Response to Submissions

GLOSSARY	I
1 INTRODUCTION	1
1.1 Background	1
1.2 Overview of Submissions and Observations Received	1
1.3 Methodology	2
1.4 Structure of this Response	3
2 REGISTER OF SUBMISSIONS & OBSERVATIONS	7
Local Authority	7
Dublin City Council	7
Prescribed Bodies	7
EPA	7
Index No. 3 - Inland Fisheries Ireland	7
Index No. 23a - Department of Housing, Local Government and Heritage, National Parks & Wildlife Service (NPWS)	8
Index No. 23b - Department of Housing, Local Government and Heritage, Development Applications Unit, National Monuments Service (NMS)	8
Index No. 6 - National Transport Authority	8
Index No. 47 - Transport Infrastructure Ireland	8
Index No. 49 - Department of Transport	8
Index No. 4 - Health & Safety Authority	8
Index No. 48 - Uisce Éireann	9
Index No. 13 - Electricity Supply Board (ESB)	9
Index No. 50 - Maritime Area Regulatory Authority (MARA)	9
Index No. 46 - DECC Geological Survey Ireland	9
Commercial Organisations	9

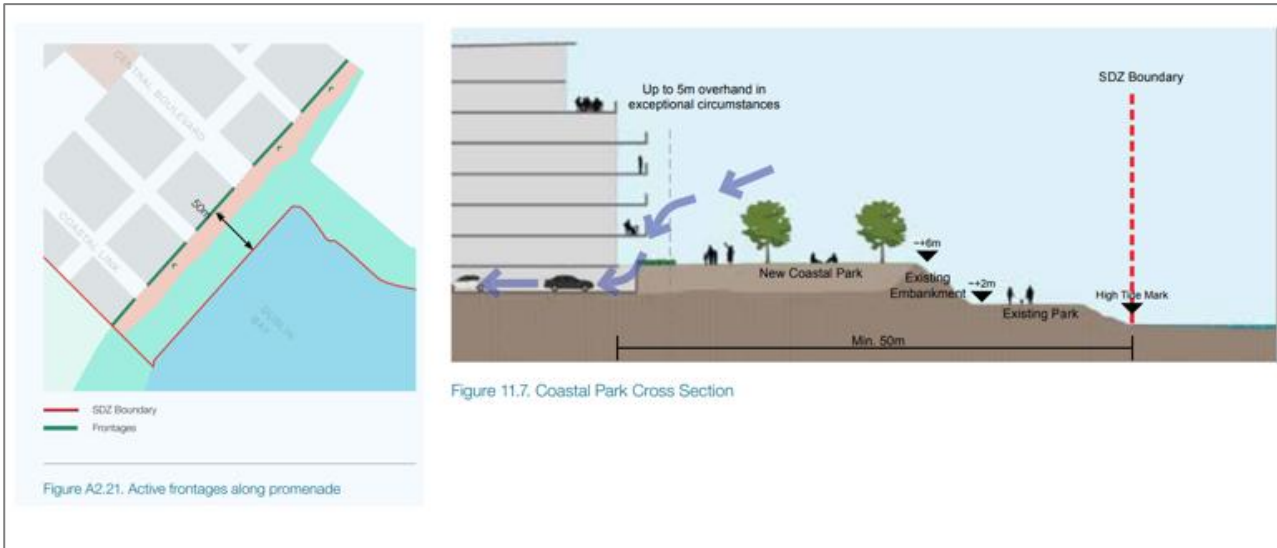
Regarding the 50m setback requirement, Figure A2.21 of the Planning Scheme provides a visual representation of this requirement and should be considered for understanding its practical implementation. Figure A2.21 of the Planning Scheme is reproduced here for clarity and context.

Figure A2.21 clearly indicates that the 50m setback requirement applies only to the western edge of the Coastal Park, not to the eastern edge where the Ro-Ro Terminal Area (O) is proposed. In this regard, it is evident that SAMRA's claims regarding the non-compliance of the 3FM Project with the Planning Scheme's requirements are unfounded. As evidenced in Figure A2.21, the 50m setback requirement applies to the western edge of the Coastal Park, therefore, it would not be relevant or applicable to the Ro-Ro Terminal Area (O). SAMRA's claims regarding alleged encroachment based on the failure to comply with the 50m setback requirement are also mistaken.

Furthermore, Figure 11.7 of the Planning Scheme, also reproduced above, provides further clarity on the interpretation of the 50m setback requirement. This figure provides a detailed cross-section of the Coastal Park, illustrating that the 50m setback extends from the shoreline boundary of the SDZ, defined by the high tide mark, to the building line in Area A. As shown, the area within the 50m distance accommodates the boundary treatment to the east of the building line.

Figure 3.2.1: Extract from Drawing CP1901-3FM-RPS-S45-07-DR-C-0701 (annotated)

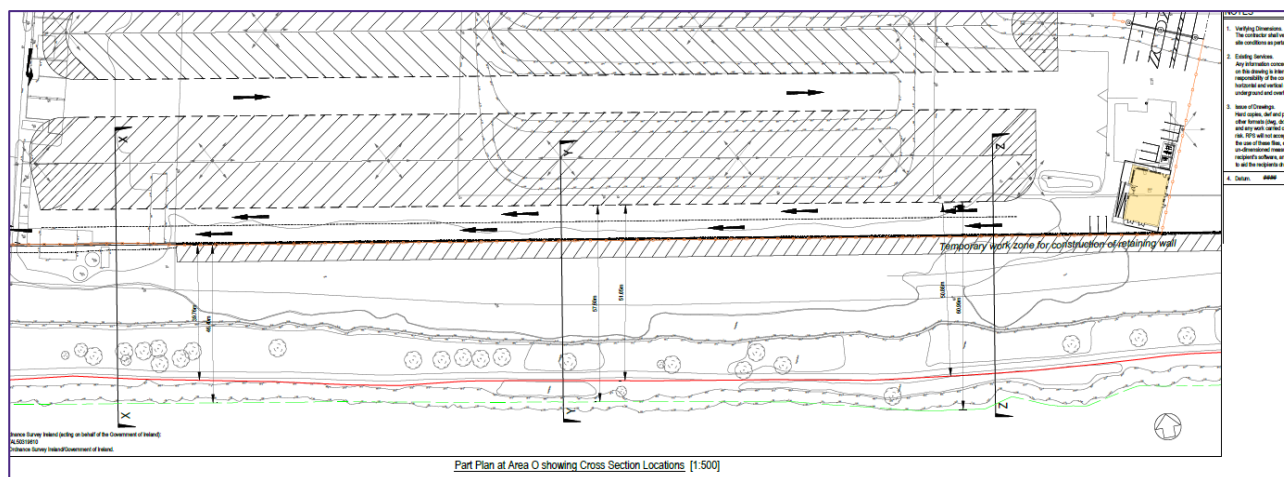
- The proposal includes trailer parking situated parallel to the Coastal Park's eastern edge. The closest distance from the proposed trailer parking to the high tide mark is 57m (see Drawing CP1901-3FM-RPS-S45-07-DR-C-0701 enclosed with the application with dimension added in Figure 3.2.1 below).

- The distance from the proposed retaining boundary wall to the high tide mark ranges from 43.5m and 49.8m (see Figure 3.2.1 below). However, it is important to note that this is a retaining boundary wall, not a building, and guidance set in Figure 11.7 of the Planning Scheme should be considered (i.e., the 50m setback should be from the building line to the high tide mark, and the boundary treatment, is to be placed close to the building line but not necessarily at the 50m setback mark). Thus, the proposed retaining wall provides an appropriate distance as per the guidance set in Figure 11.7 of the Planning Scheme (reproduced above).

While the Planning Scheme does include a 50m setback requirement concerning the Coastal Park, this is not relevant in the context of the 3FM Project and development within Area B2. Even in this instance, the proposed Ro-Ro Terminal Yard (Area O) has been designed in a manner which provides an appropriate separation distance to the shoreline.

Figure 3.6.1 Waterbird response to construction disturbance NIS Figure 4.5 (from Cutts *et al.* 2009)¹³.

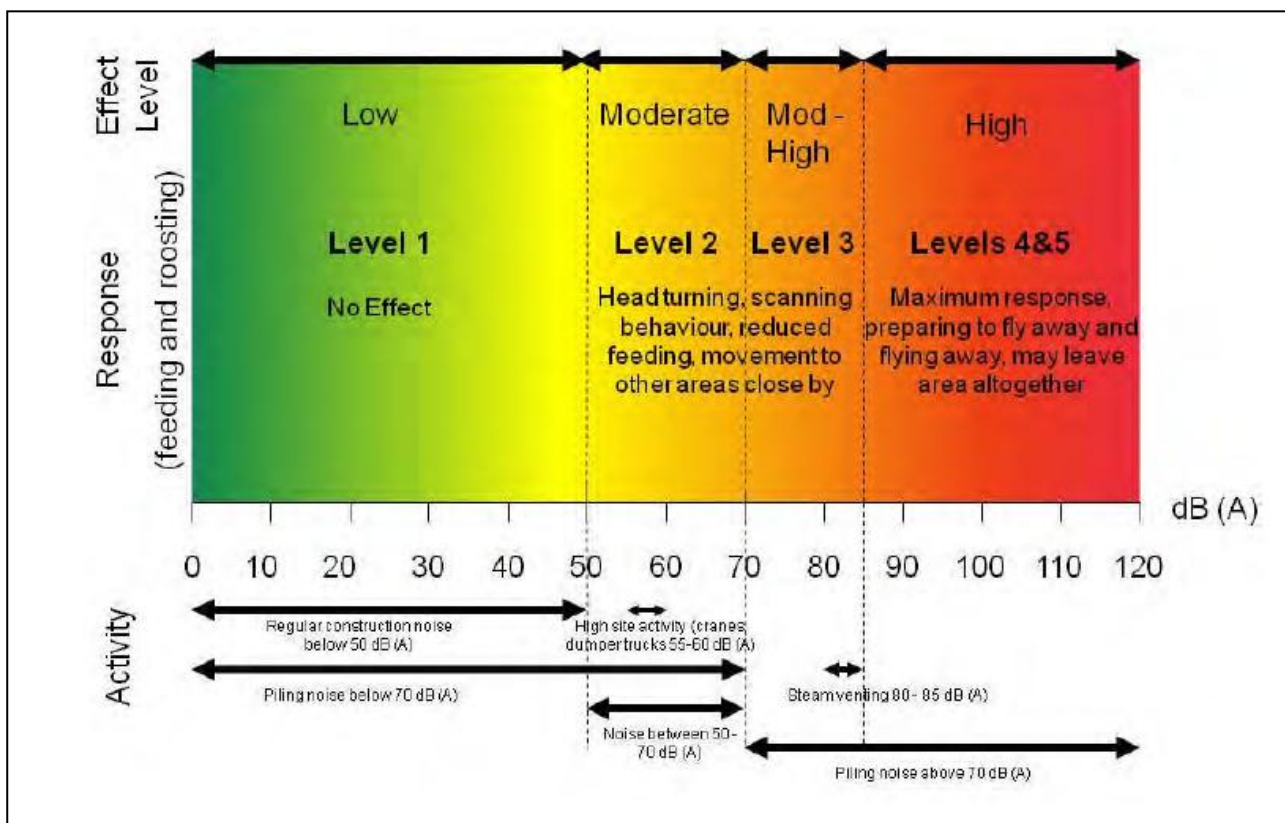
Figure 4.5 of the NIS (illustrated as Figure 3.6.1 below) shows this worst case scenario as falling within the 'level 2 – moderate' response range. The literature cited in the NIS (Cutts *et al.*, 2009) considered impacts to birds utilising the Humber Estuary and summarised the general thresholds due to the potential effects of construction disturbance on birds. A Waterbird Disturbance Toolkit²⁴ developed by TIDE²⁵ (Cutts *et al.* (v3.2), March 2013) evolved from this earlier study by Cutts *et al.* and usefully includes assessment predictions of how waterbirds will respond to a variety of noise sources, including a summary graphic of likely disturbance effect for a noise level and distance of receptor from source.

Cutts *et al.* (2009) showed that birds were found in general, to accept a wide range of steady state noise level from 55dB(A), up to 85dB(A), therefore complete exclusion within up to 250m was considered very unlikely. The study also presented evidence from repair work to a pipeline in the Humber Estuary has shown that disturbed birds (within 100m) are likely to return within a short time frame once disturbance ceases, potentially within 30 minutes, and with no evidence of effects on numbers during surveys the following week, emphasising the short-term nature of any impacts.

Birds in all parts of the SPA are expected to rapidly habituate to construction phase noise sources, including piling noise, and there will be no adverse effects upon the integrity of South Dublin Bay and River Tolka Estuary SPA.
